**LOG OF MEETING  
DIRECTORATE FOR ENGINEERING SCIENCES**

**SUBJECT:** Outdoor Specialty Gas Cooking Appliance Technical Advisory Group  
(TAG) Meeting.

**DATE OF MEETING:** September 24 and 25, 2002

Figure XX. Incandescent Particle Acceptability ILLUSTRATION

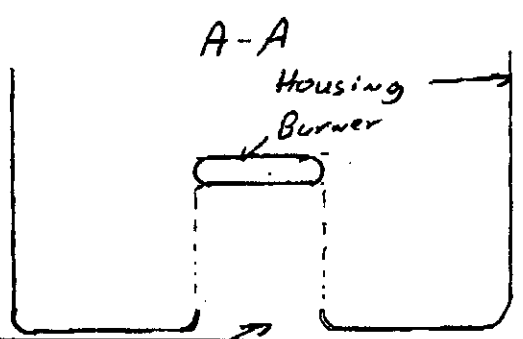
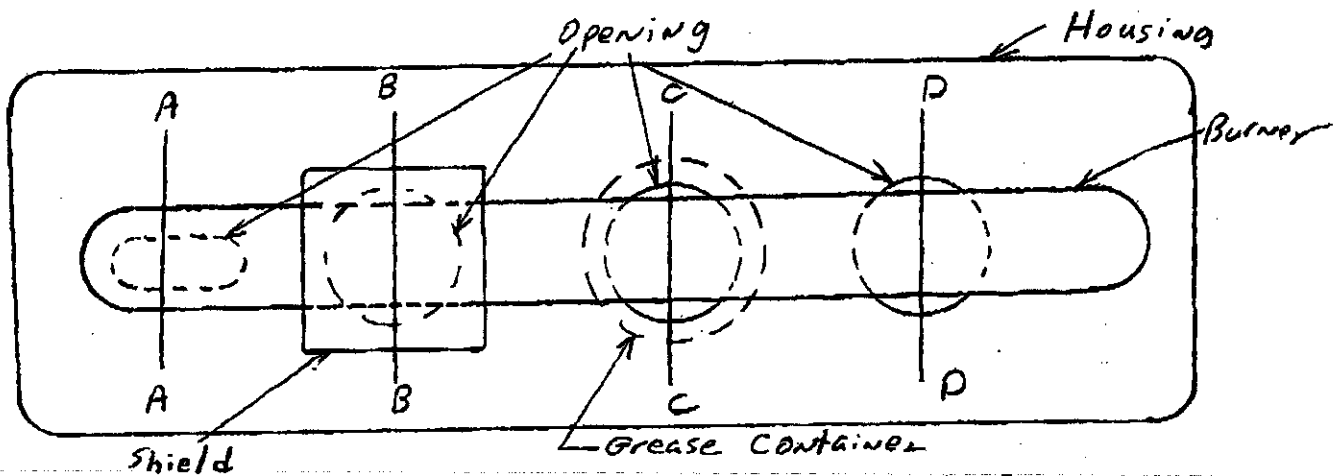
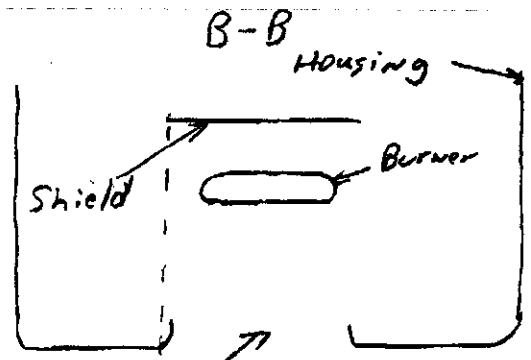
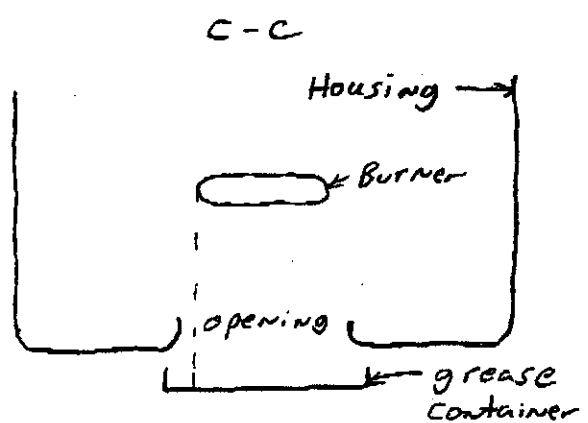
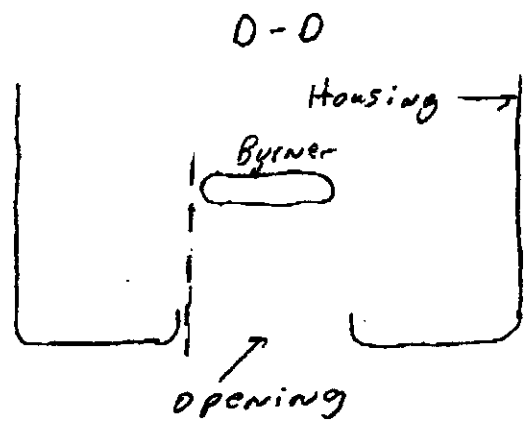
A vertical plane from any edge of the burner(s) or burner shield(s), or any edge of an opening in a heat distribution plate(s), shall not pass through an opening in the bottom of the appliance housing. A plane which is obstructed by a grease tray is acceptable (See Figure XX).

This proposed revision is a result of a task force established during the February 2002 sub-committee meeting. The task force was established due to a proposed change to section 1.15.5 rejected at the meeting.

The original proposal was made due to the opinion that the current wording is confusing. The task force held a telephone conference call on May 17, 2002 and the key points of that call follow. Some task force members felt that there was no problem with wording and no change needed. Others felt it could be improved. A point made was that the current location in the standard in section 1.15 does not make it clear that this even applies to the main portion of the grill. For this reason one change proposed is to move the requirement to section 1.3 covering the appliance structure. The original concern was with the wording "below the burner" which was thought to be restrictive and unclear. Simply removing the "below the burner" was thought to make the requirement even more vague. Another concern expressed was with the meaning of the word "housing". Task force discussion also covered how placement of radiant material such as lava rock, briquettes, etc. should be handled. One task force member expressed concern that the requirement could not easily be understood. A sketch was recommended.

- 1 Move the requirement from section 1.15 to 1.3. This makes it clearer that the requirement is for the main part of the grill and not just the top burner.
  - 2 The wording "below the burner " was deleted.
  - 3 A section is added 2.18 which defines how to evaluate the appliance for incandescent particles.
5. ... This proposal is original material.  
•X•
